MANSOURAH - MASSARAH GOLD PROJECT
GENERAL ARRANGEMENT DRAWING
OXYGEN PLANT
FOUNDATION LOAD - LIQUID DISPOSAL SYSTEM

DRAWING NUMBER: MD-216-3980-EG-CV-GAD-V551-1496 — REV: D01

Mansourah Massarah Gold Project
Comment Resolution Log Sheet / Compliance Report

FOUNDATION PLAN LIQUID DISPOSAL SYSTEM

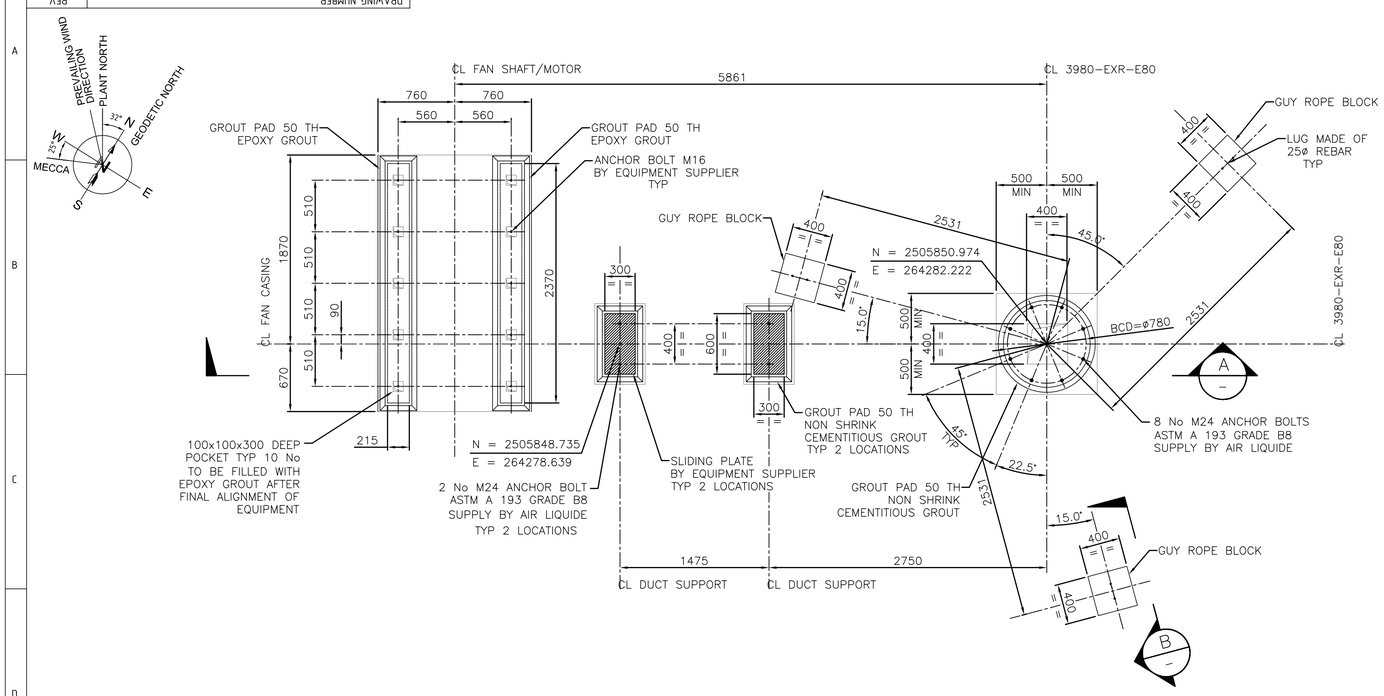
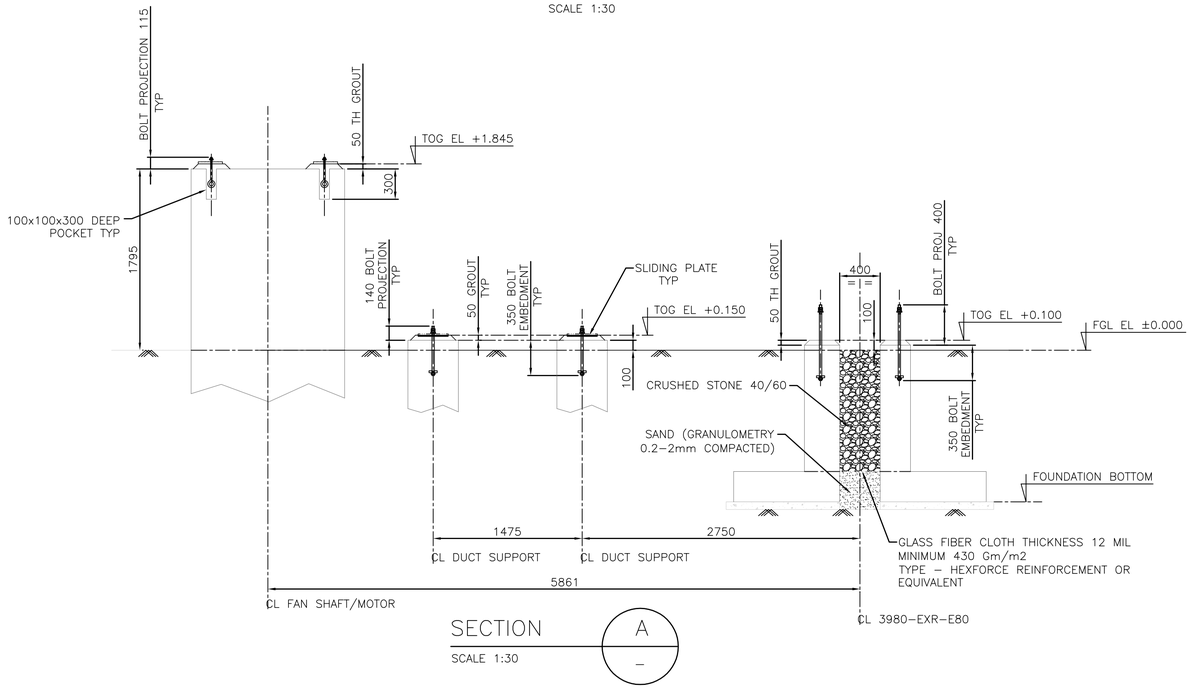
DOCUMENT NUMBER	Area / Title	Comment No.	PMC/PMT COMMENT DATE: 27 October 2020	Comment by	EPC Response DATE: 07 January 2021	Status	Remarks
			General Comments (cc)				
MD-216-3980-EG-CV-GAD-V551-1496-A01	3980	1	Please establish specific which codes are you using for wind and seismic. Refer to the project design criteria	Mr. Doron Golan - Bechtel	Comment incorporated.	Closed
